Type B(U) Package for Fissile Materials

INDEPENDENT REVIEW OF DOCUMENT 0908-LE01-3BEIN-024-B: LEUPA – CRITICALITY ANALYSIS

December 12, 2012

Figure 3: Horizontal section of the square arrangement of 5*N LEUPA packages, reflected by 30 cm of water

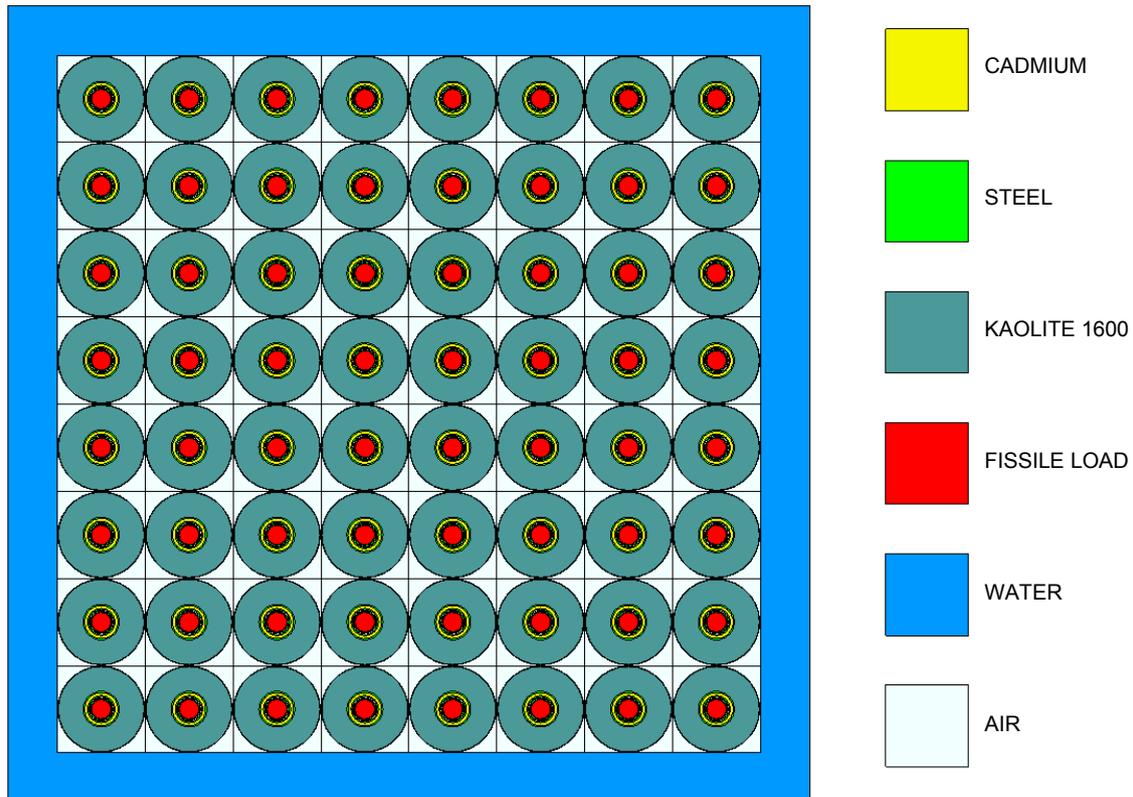
1. The multiplication factor (k_{ef}) for fivefold “N” packages (384 in this specific case), without the presence of water, and with the geometry modeled as described in reference document [2] (MCNP) and section 7.2 (SCALE) is as follows (Figure 3:):

| $k_{ef} + 3\sigma (\sigma < 0.0003) = 0.53898$ (SCALE) $k_{ef} + 3\sigma (\sigma < 0.0002) = 0.45798$ (MCNP [2]) |

2. Although both results indicate that the set of packages is subcritical by a wide margin, there are doubts as regards the reasons for the difference between the results obtained with MCNP and SCALE.
3. In order to understand those differences, two additional calculations were made:
 - a. With SCALE, where the fissile material fills the entire interior container (using a fictitious density for uranium in such a way as to fill all the interior container and keeping the nominal mass);
 - b. With MCNP, where the fissile material is modeled with its real density, so that the nominal mass fills the interior container only partially, as shown on Figure 2:.. This model was developed based on the model used to obtain the results reported in [2].
4. The set of multiplication factors obtained is as follows:

5. Therefore, differences in the value of k_{ef} calculated by both codes reduced to $\sim 0.02 \Delta k$, considering the differences in the chain of calculation (effective sections and calculation code), and taking into consideration the slight differences in the modeled geometry (empty spaces, detail of intermediate covers), the SCALE calculation confirms what was calculated with MCNP.

Figure 4: Horizontal section of the hexagonal arrangement of 5*N LEUPA packages, reflected by 30 cm (minimum) of water

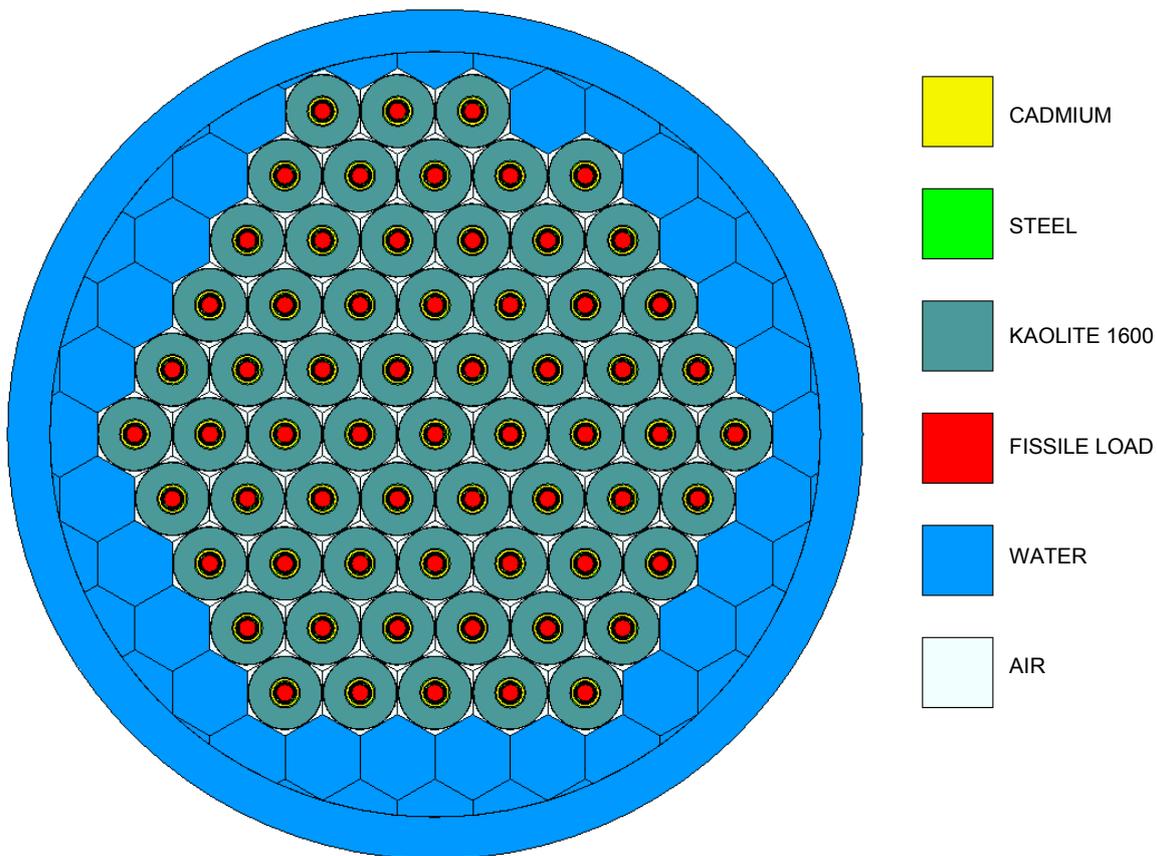
9. To evaluate the effect of assuming a different geometric arrangement of packages, a case in which packages are distributed in a hexagonal arrangement was simulated (Figure 4:), keeping the same 6 axial levels assumed on the square disposition. The result is as follows:

| $k_{\text{ef}} + 3\sigma$ ($\sigma < 0.0003$) = 0.53898 (SCALE – square disposition 8x8x6) $k_{\text{ef}} + 3\sigma$ ($\sigma < 0.0002$) = 0.56330 (SCALE – hexagonal disposition) |

10. The hexagonal arrangement is therefore the most reactive scenario, given that it is the most compact arrangement among the possible regular arrangements. Any other random disposition of packages would be less compact than the hexagonal arrangement proposed, hence its lower reactivity. The modeled case is useful to prove the subcriticality of the system of 5*N packages, regardless of the disposition (vertical or not) of the packages.

Figure 5: Variation of the effective multiplication factor based on the mass of water retained in the Kaolite 1600

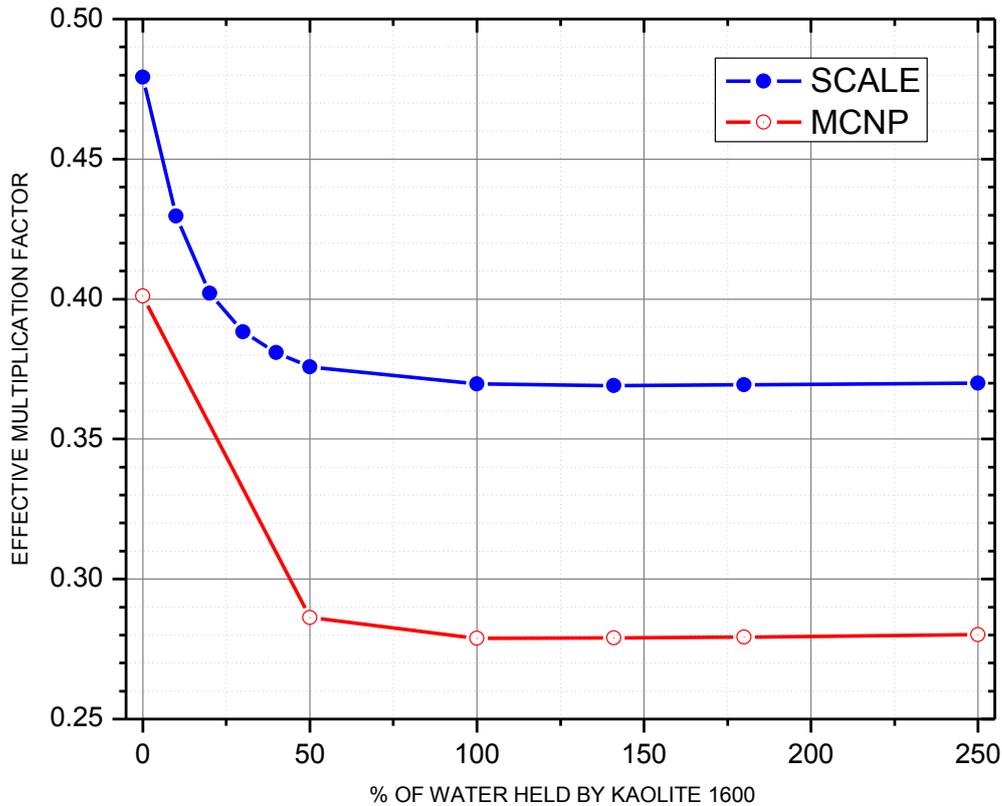
4. Figure 5: contains a graph on the values of ($k_{ef} + 3\sigma$) obtained with MCNP and SCALE, based on the percentage of water retained by the insulation.
5. The SCALE calculation confirms that the most unfavorable situation from the criticality standpoint is the case of dry heat insulation, as stated in [2].

Figure 6: Variation of the effective multiplication factor based on the density of water entering the empty spaces inside and outside the package

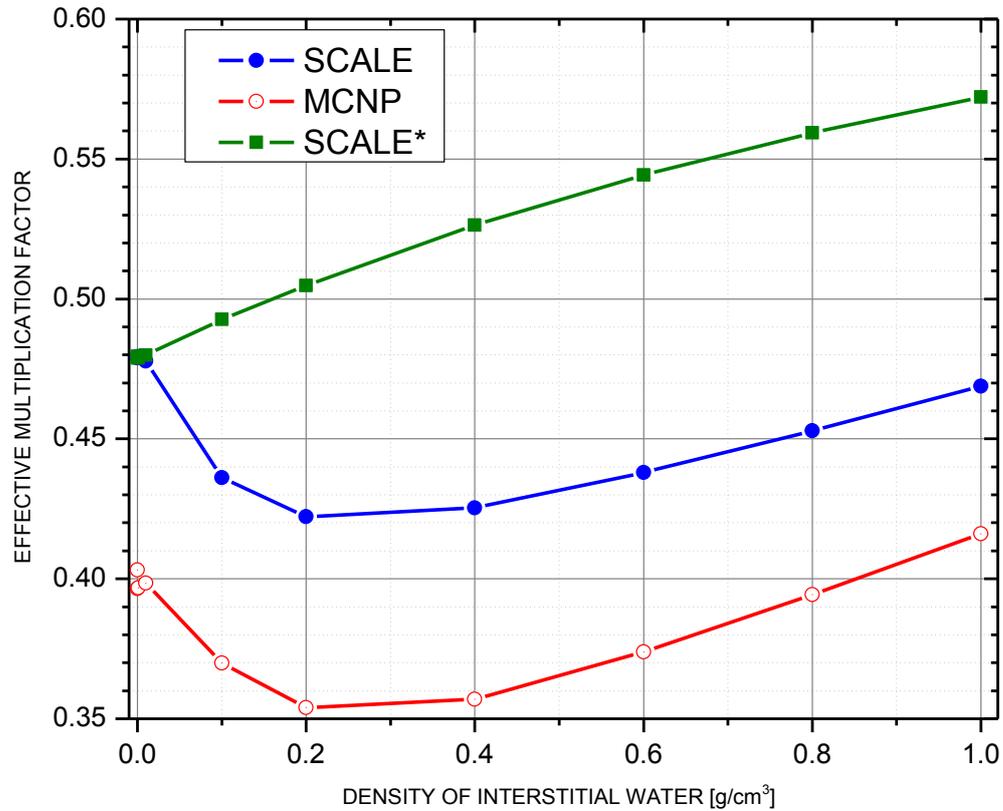
5. Figure 6: shows the values calculated with MCNP (red curve, empty circles) and SCALE (blue curve, solid circles). The existence of a minimum based on the density of the water entering the package suggests the presence of phenomena competing among them in relation to the reactivity of the system. In order to identify and separate these phenomena, another series of calculations was prepared, where the inflow of water to the package was

6. The curve indicated as “SCALE *” (green curve) in Figure 6: shows that the more reactive case is that where the water inflow only to the existing empty spaces inside the cadmium cover is simulated. This water provides moderation to the sub-moderate system and therefore the multiplication factor increases with the inflow of water.
7. On the contrary, when water is also added outside the cadmium cover, the additional moderation obtained does not translate into an increase of the effective multiplication factor of the system, since the thermalized neutrons in the area outside the cadmium cover are absorbed in the cadmium before re-entering the containers with fissile material.

Figure 7: Variation of the effective multiplication factor based on the mass of water entering each internal container

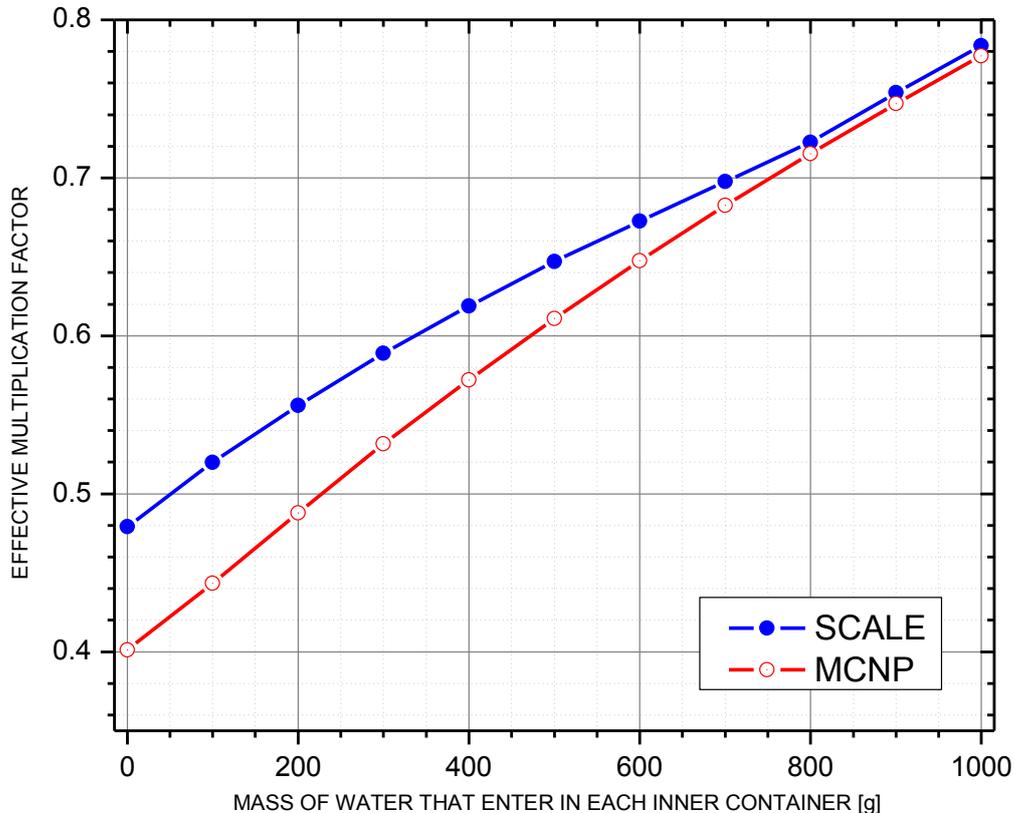
6. Figure 7: contains the calculated values.
7. We can see that the multiplication factor increases monotonously with the water mass entering the inside container. Be it reminded that, given the measurements of the internal containers and the nominal mass of uranium metal per container, it is not possible to add more than 900 g of water per internal container.
8. In all cases, the value calculated with SCALE is higher than the value calculated with MCNP. The difference between both calculations is reduced to a minimum as the mixture of water+uranium metal modeled in SCALE fills the free volume of each interior container, since the differences in the fissile volume modeled with both codes is reduced when water is added to the container. This behavior confirms what is stated in section 7.4.1, paragraphs 3 to 6.

Figure 8: Variation of the effective multiplication factor depending on the density of water entering the gaps in the packages arrangement, when the insulation is dry

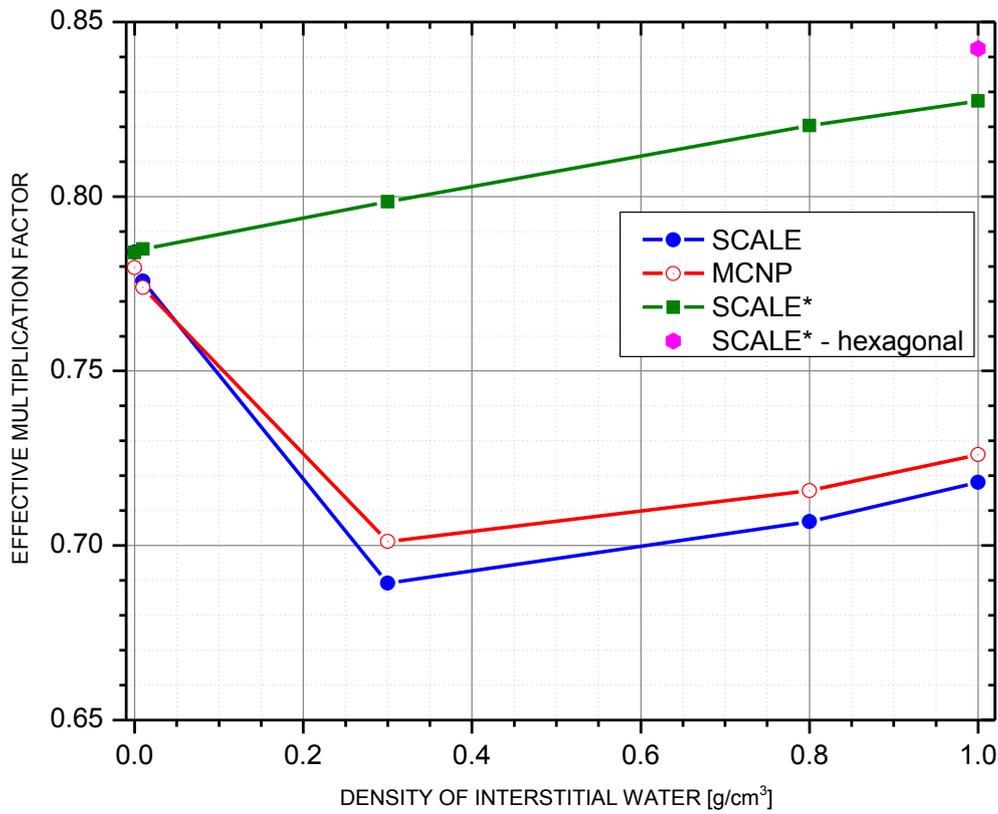
12. Cases resulting in the maximum k_{ef} obtained with MCNP and SCALE are highlighted in Table 5:.
13. Figure 8: contains a graph of the results obtained with MCNP and SCALE, for cases where the insulation is dry, for different densities of water entering the gaps (homogeneous inflow of water in all the gaps of packages, and inflow of water only to the gaps located to the interior of the confinement, indicated with the label "SCALE *" in Figure 8:).

14. In all those cases, a square arrangement of packages was simulated in the system. Figure 8: also shows a calculation point that corresponds to the simulation of a hexagonal arrangement of packages in the system ($k_{ef} + 3\sigma = 0.84234$).

Figure 9: Multiplication factor depending on the density of the interstitial water, for different cases in which cadmium did not infiltrate into the cadmium chamber

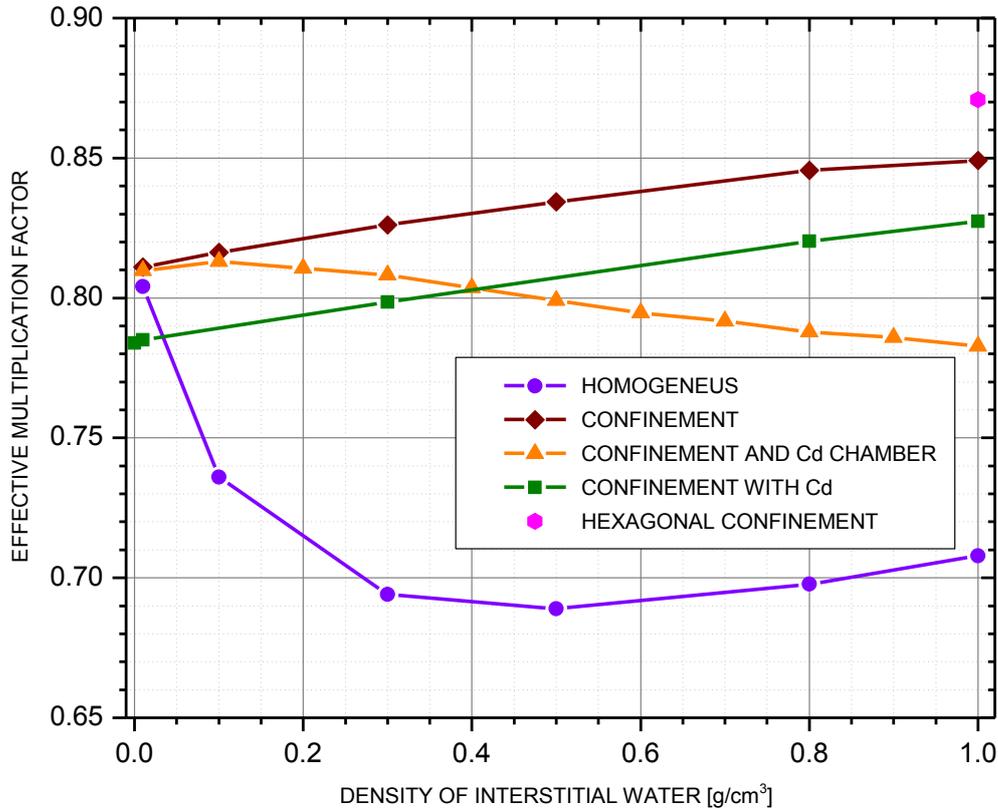
9. The curve displayed in Figure 8: is repeated in Figure 9: when water enters only the interior of the confinement (curve labeled as “confinement - with Cd”), for the sole purpose of making the effect of removing the cadmium from the cadmium cover visible.

10. In all those cases, a square arrangement of packages was simulated in the system. Figure 9: also shows a calculation point that corresponds to the simulation of a hexagonal arrangement of packages in the system ($k_{ef} + 3\sigma = 0.87083$).

11. It can be seen that, again, the worst case is the one in which internal containers are flooded with water (1000 g of water), the insulation is dry, water enters only into the gaps within the confinement, and the density of water in these empty spaces is equal to 1 g/cm^3 . This case, which yielded the highest effective multiplication factor of all those evaluated so far, shows that even under the hypothesis of this accidental case, the subcriticality of the packages system is assured with one sufficient margin.
